Contract No. T200301601.01
Federal Aid Project No. ESTP-K137 (2)
CARTER ROAD (K137)
Kent County

Enclosed is Addendum No. 1 for the referenced contract consisting of the following:

CARTER ROAD (K137)

TYPICAL SECTIONS		SHEET NO.
		8
		TOTAL SHTS.
		134

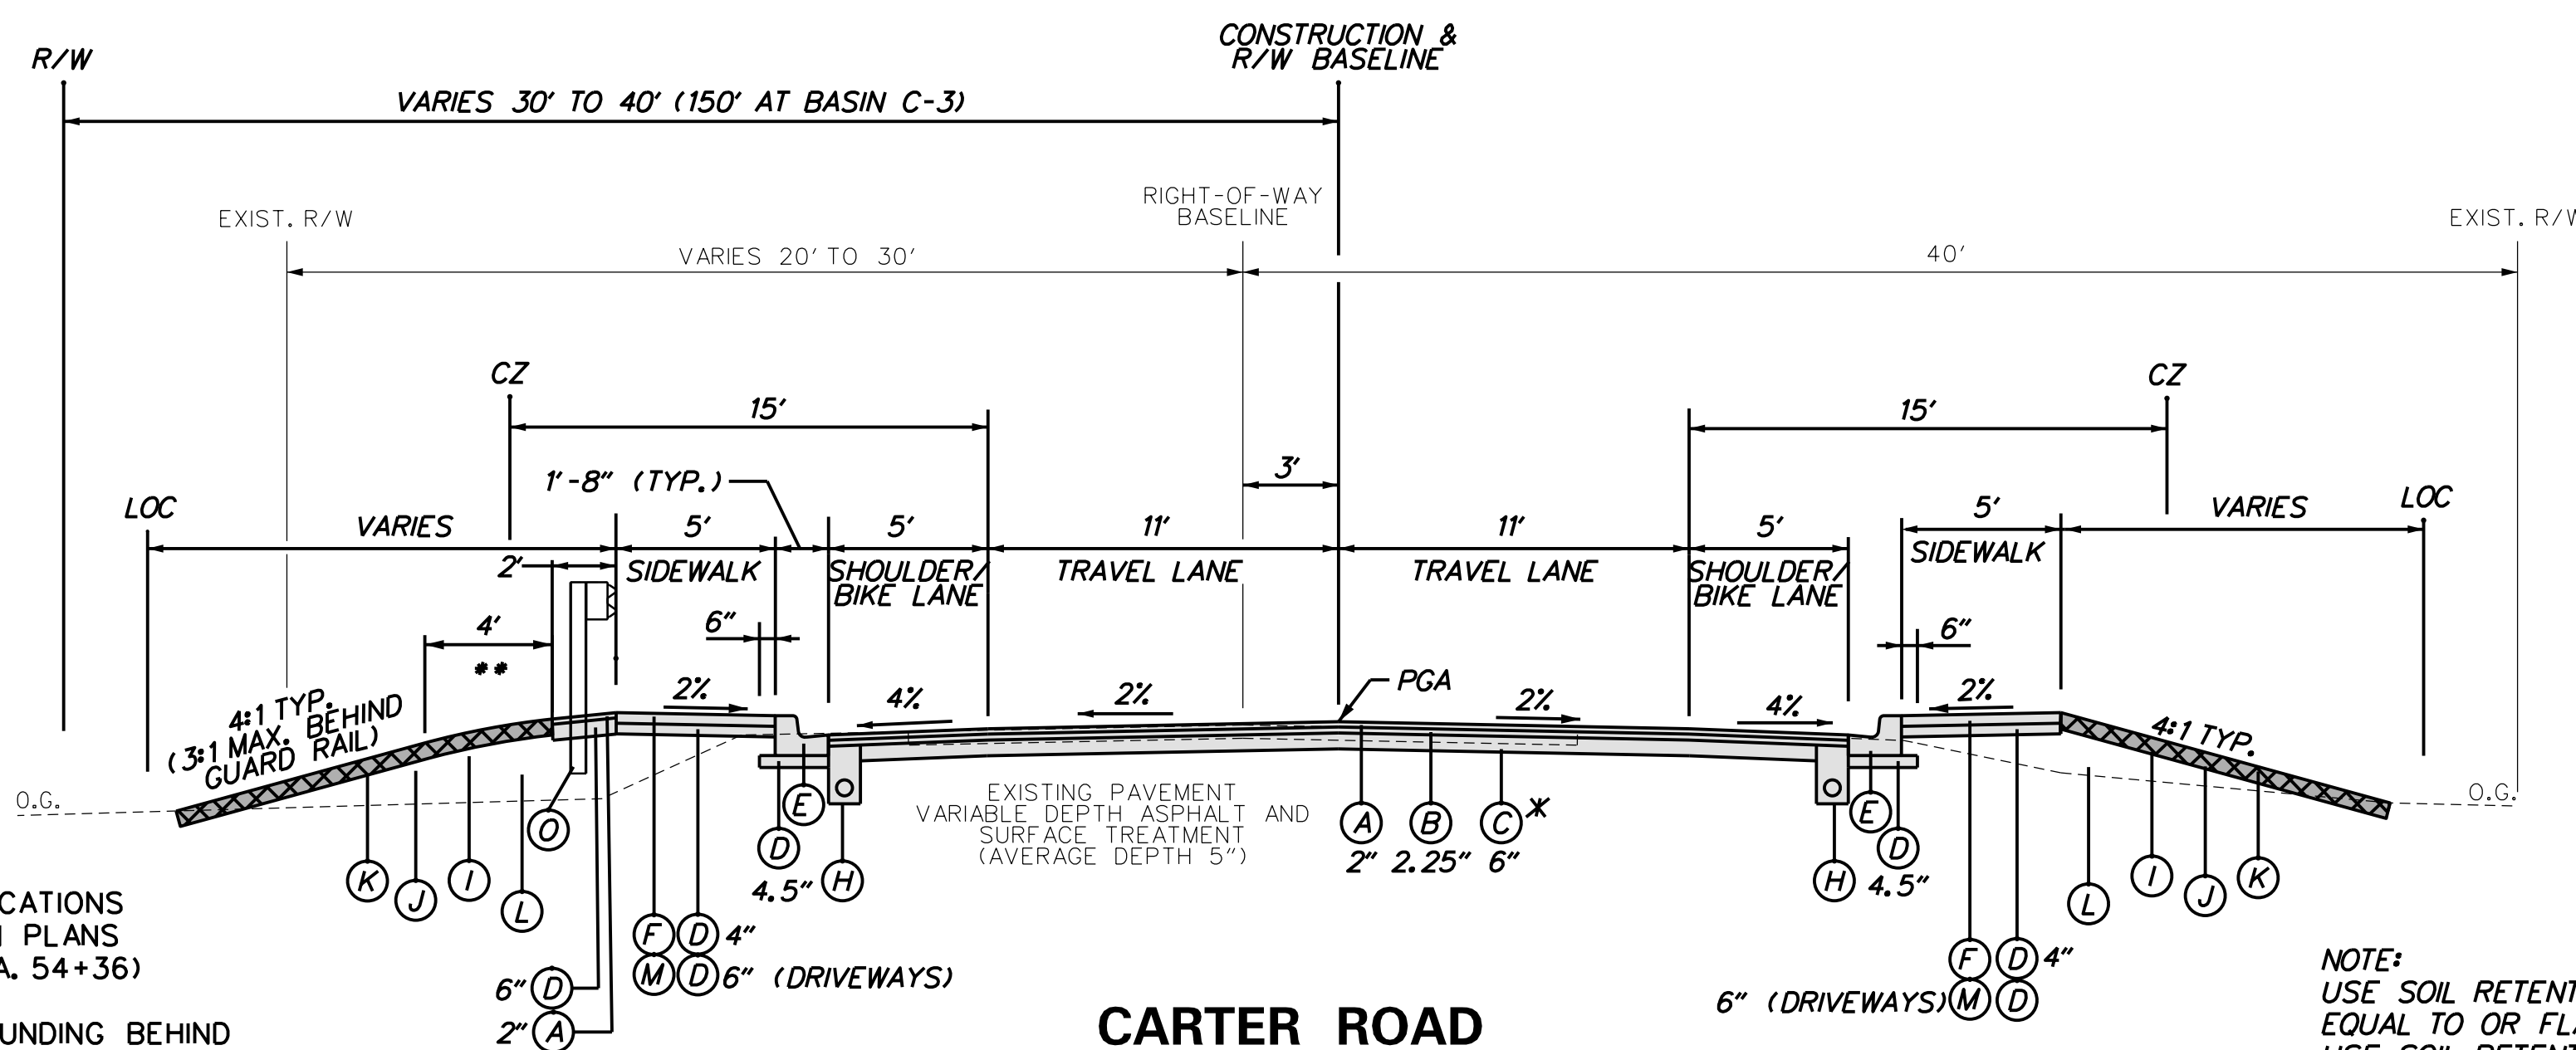
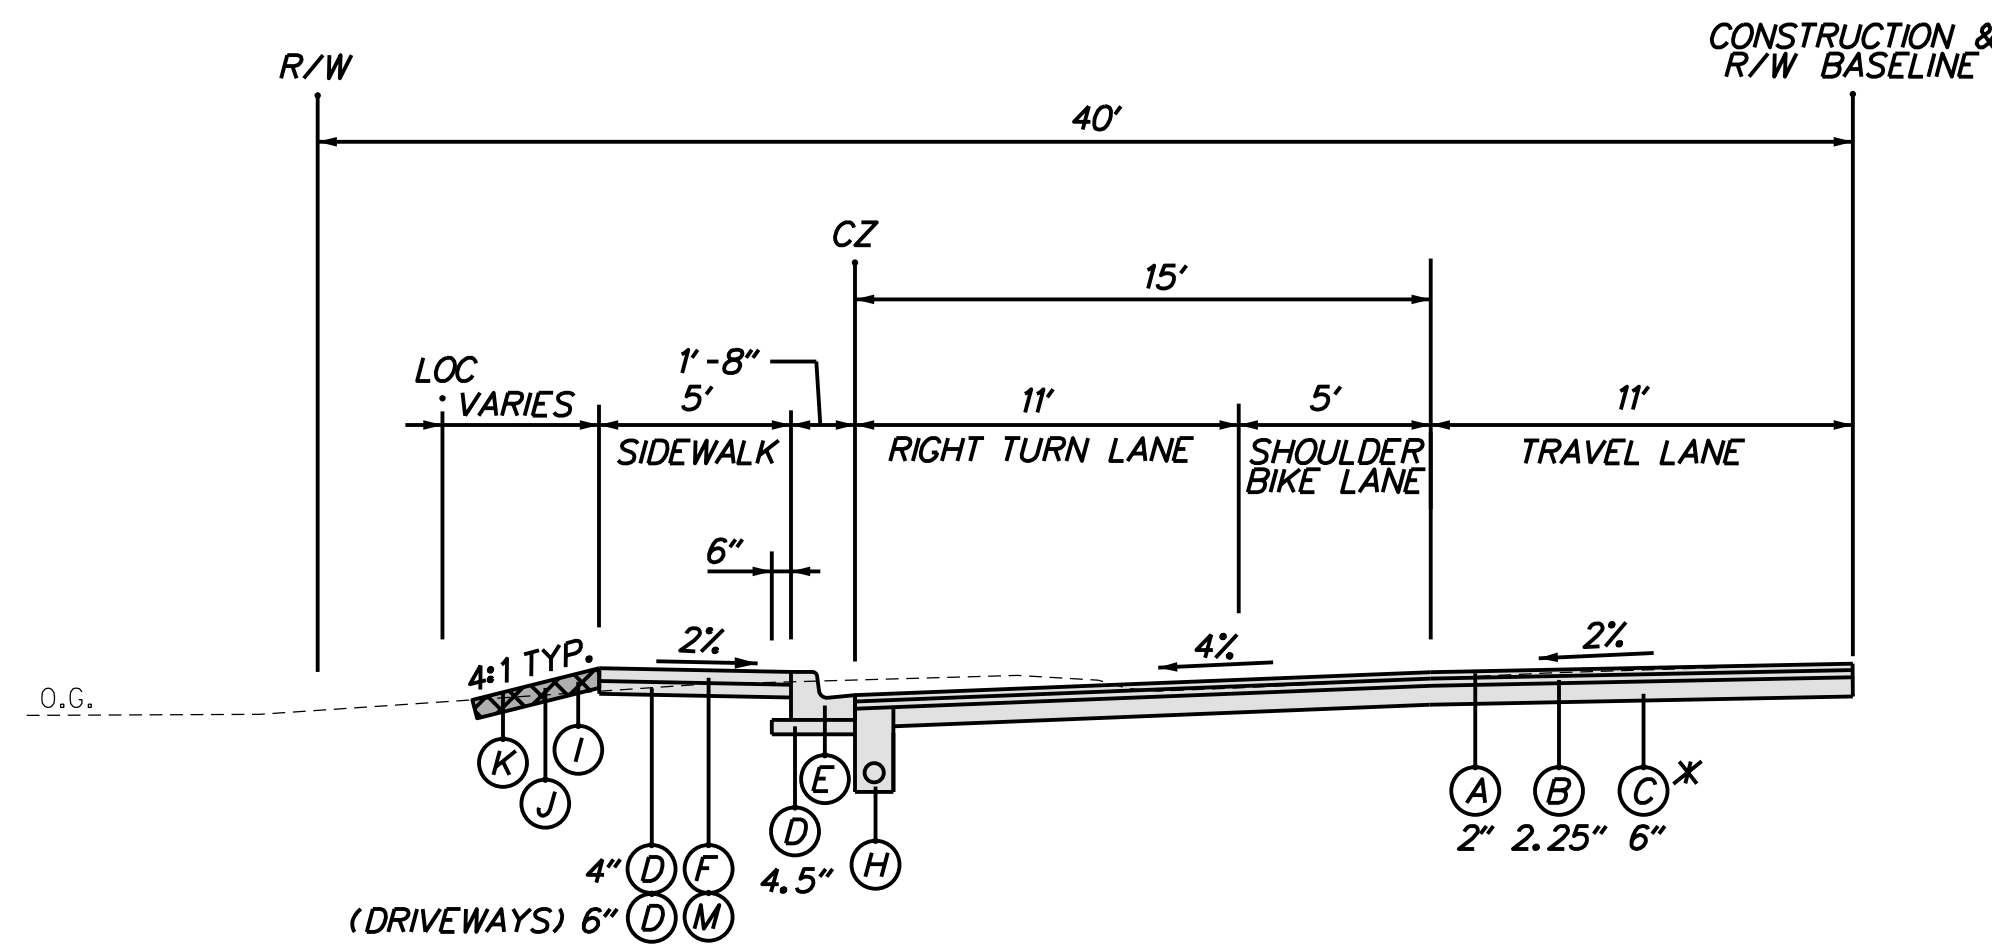
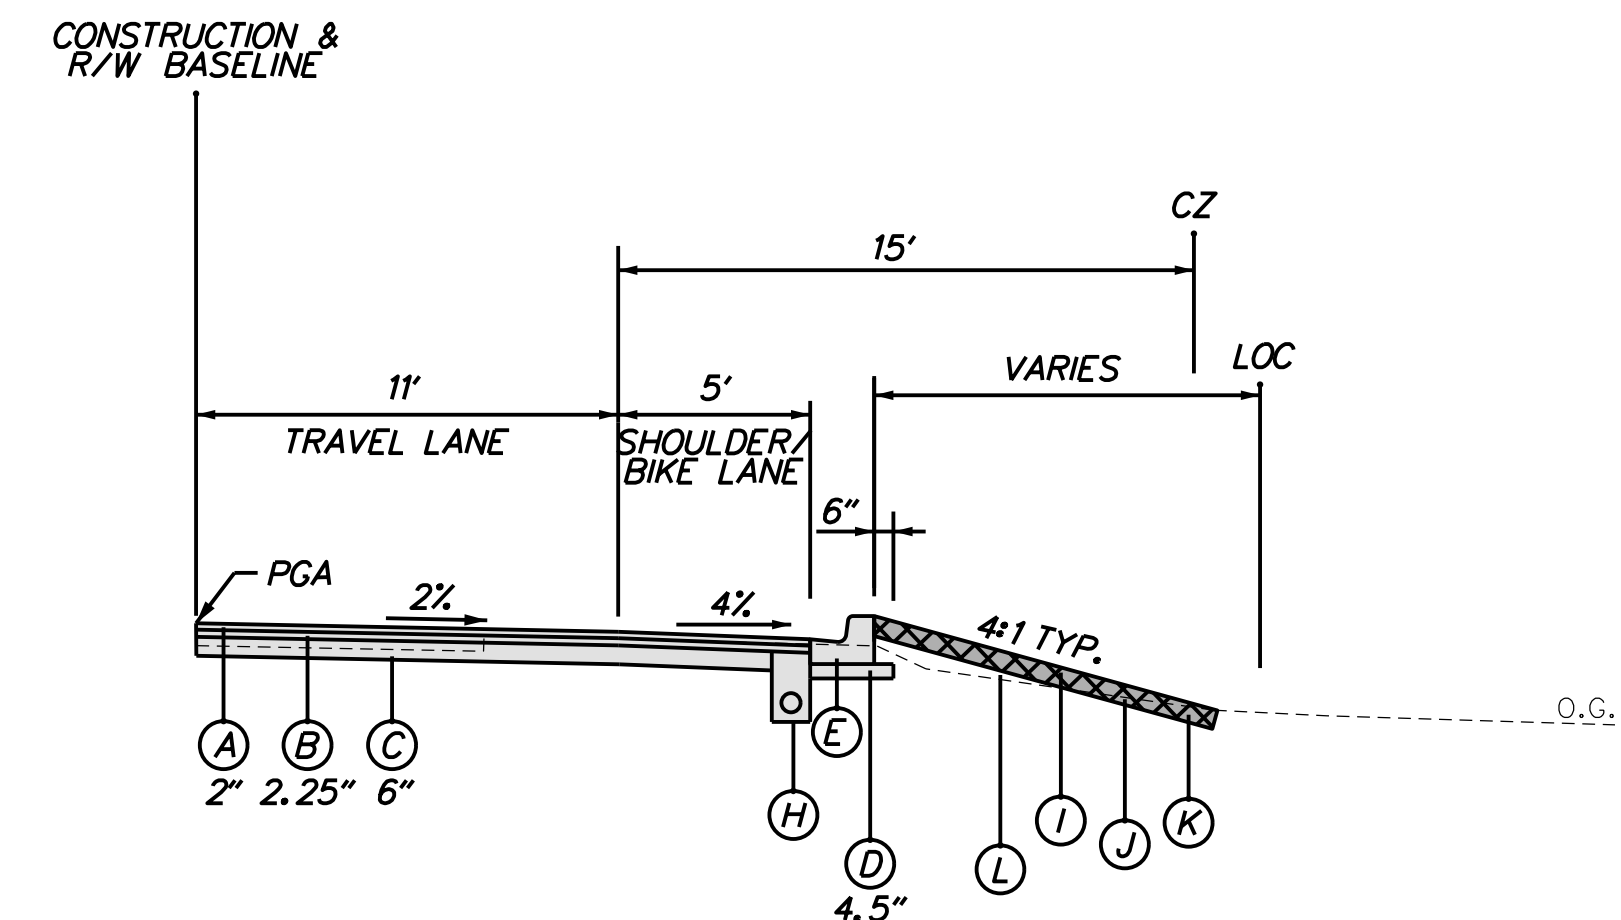
28. Per the full depth reclamation notes contained on typical sheets (plan sheet 8 for example):

- A. Is the 3" milling of the existing travel way paid under the milling item?

- B. How is the contractor paid for placing the millings in area excavated beyond the existing roadway?

- C. Is the depth of excavation in this area 6"?

ADDENDUMS / REVISIONS
△ REVISED NOTE SHEET NUMBER, CORRECTED G/R OFFSET TO BE AT FACE OF CURB WHEN NOT BEHIND SIDEWALK

Yes, the 3" milling is paid for under item #760507, Profile Milling, Hot Mix

There is no separate payment for placing the millings in the widened area. The costs are incidental to item #760507.

The depth of excavation varies based on existing roadside grades. The widened area must be excavated as needed to meet proposed grades.

CONSTRUCTION PLAN		SHEET NO.
		18
		TOTAL SHTS.
		134

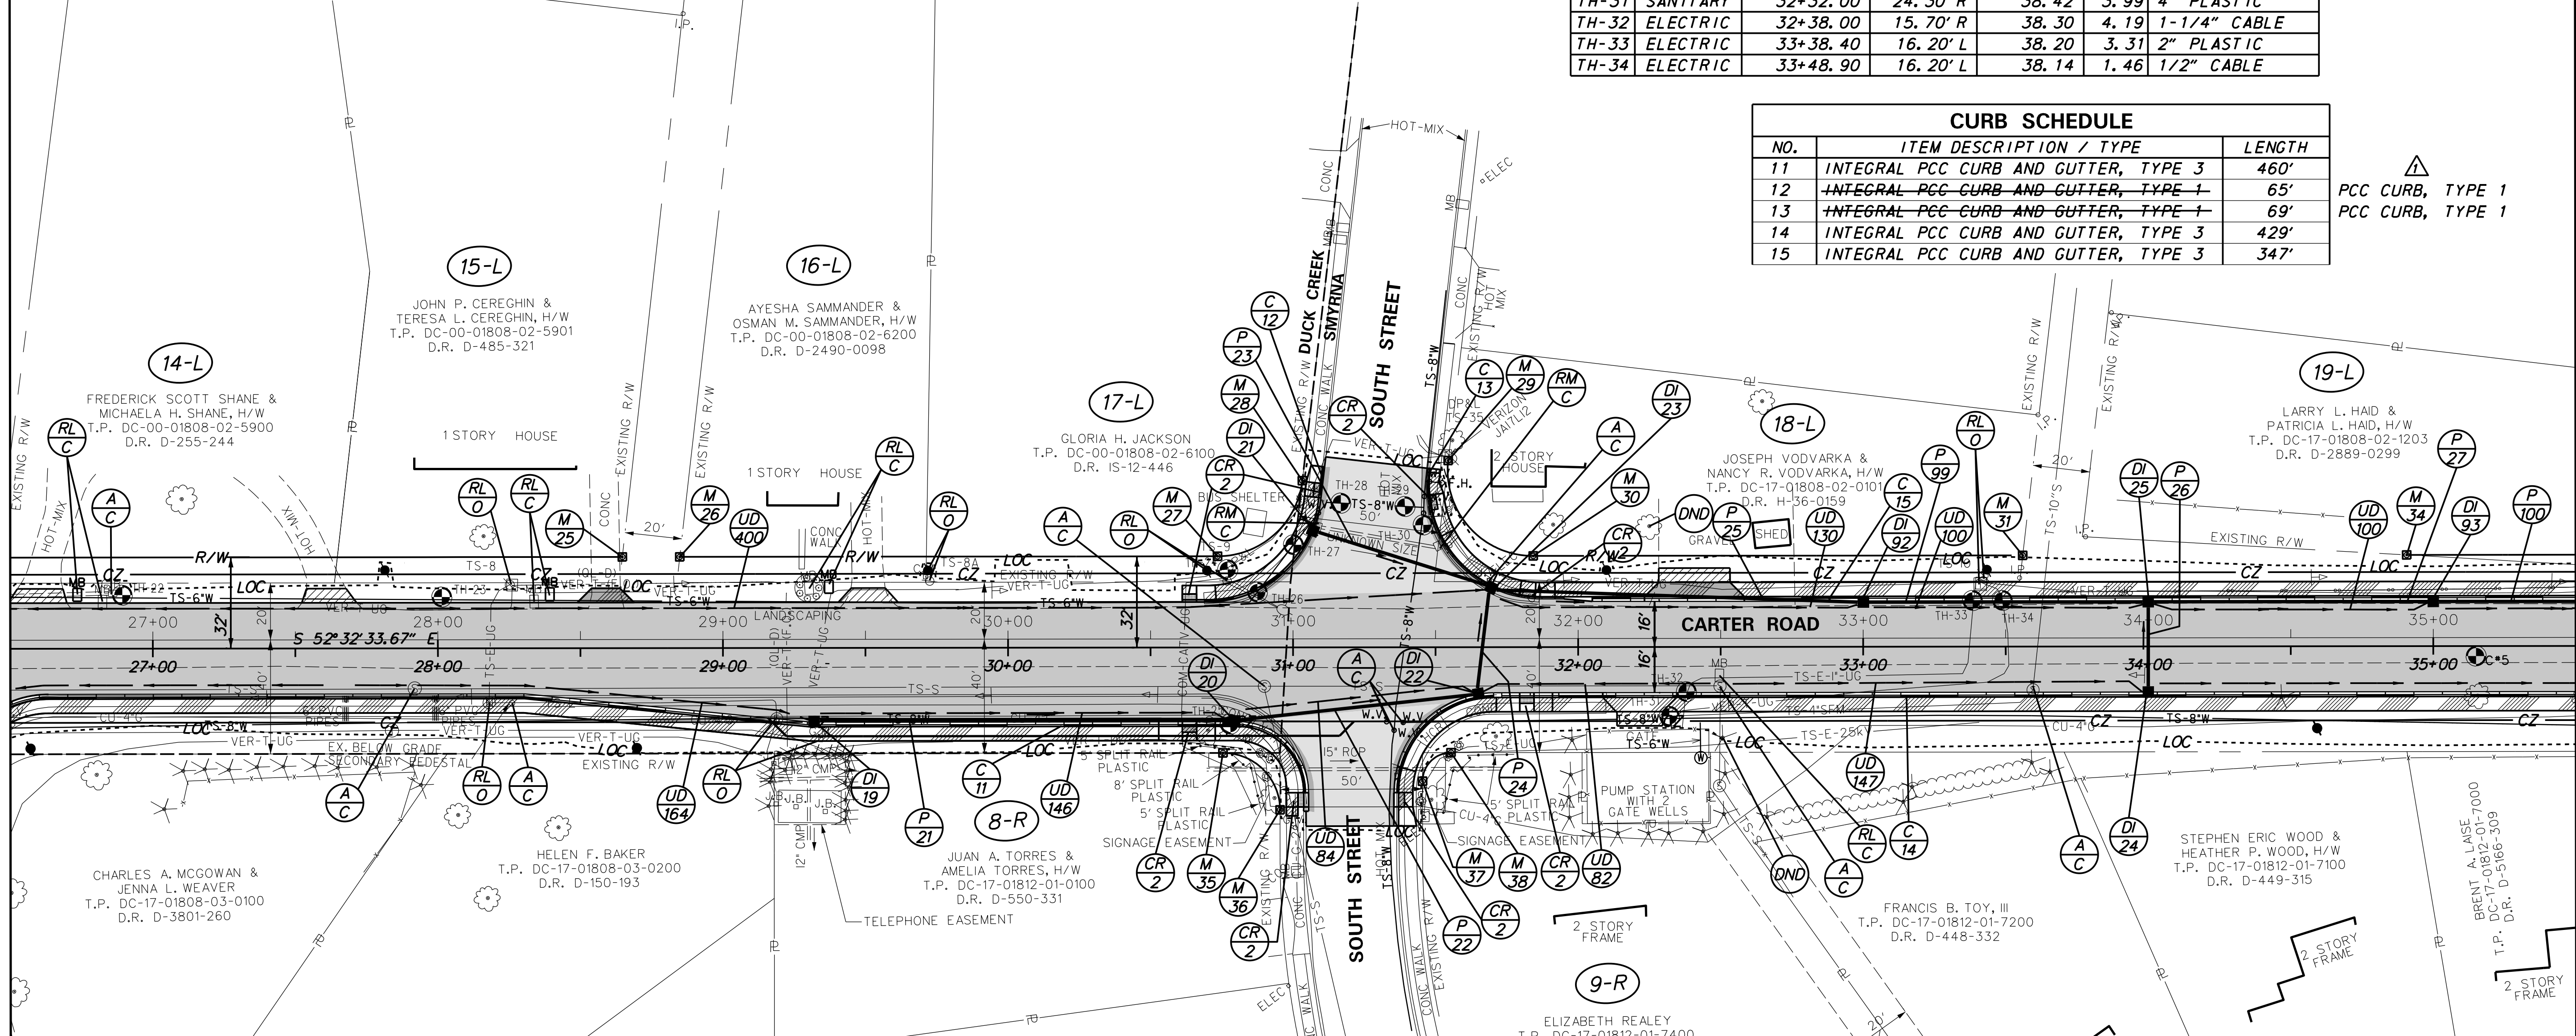
ADDENDUMS / REVISIONS	
▲	REVISED C-12 & C-13 CURB TYPES

SHEET NO.
20

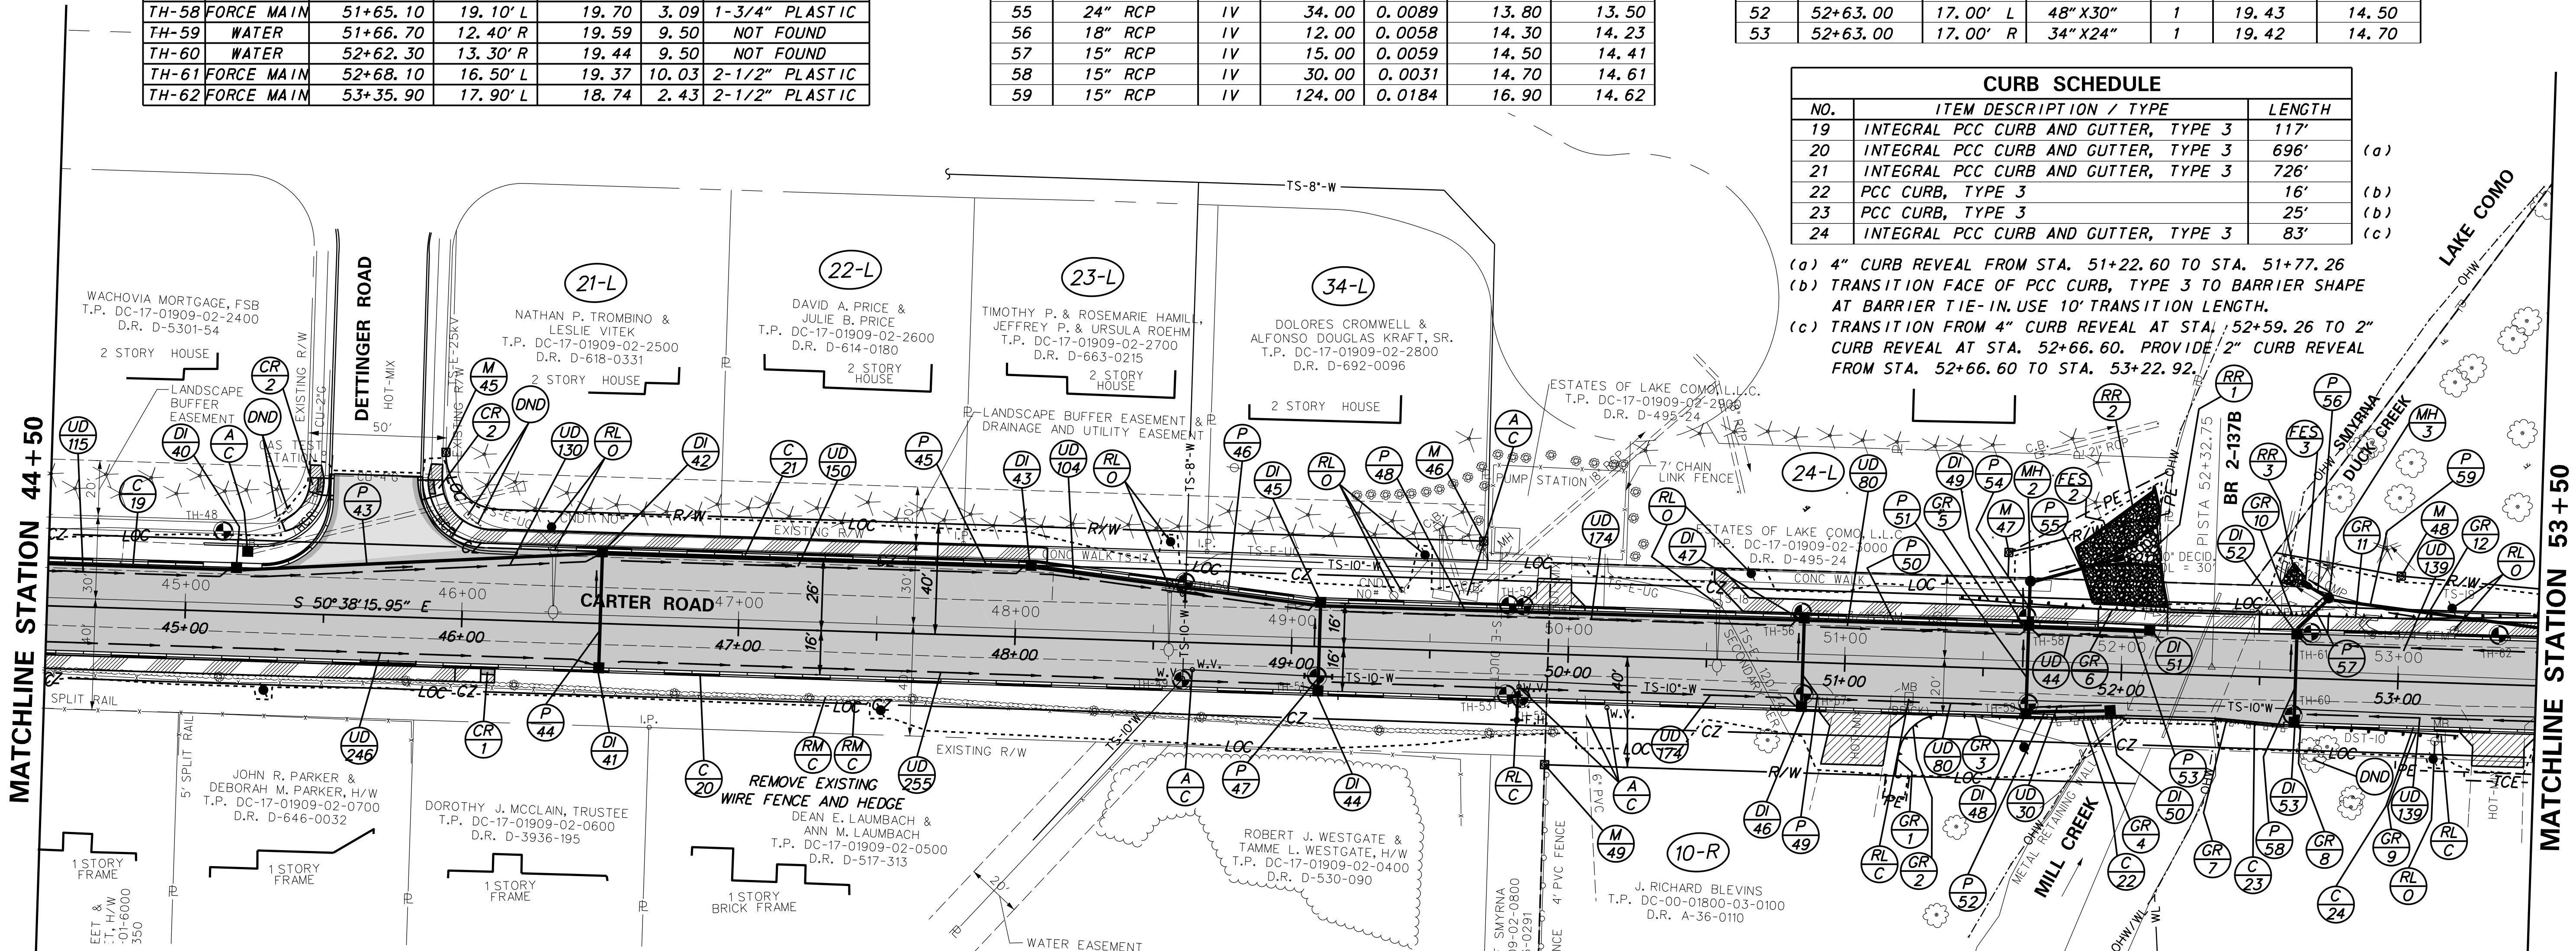
9. Is DI-88 supposed to be a 66" x 30" inlet?

Yes.
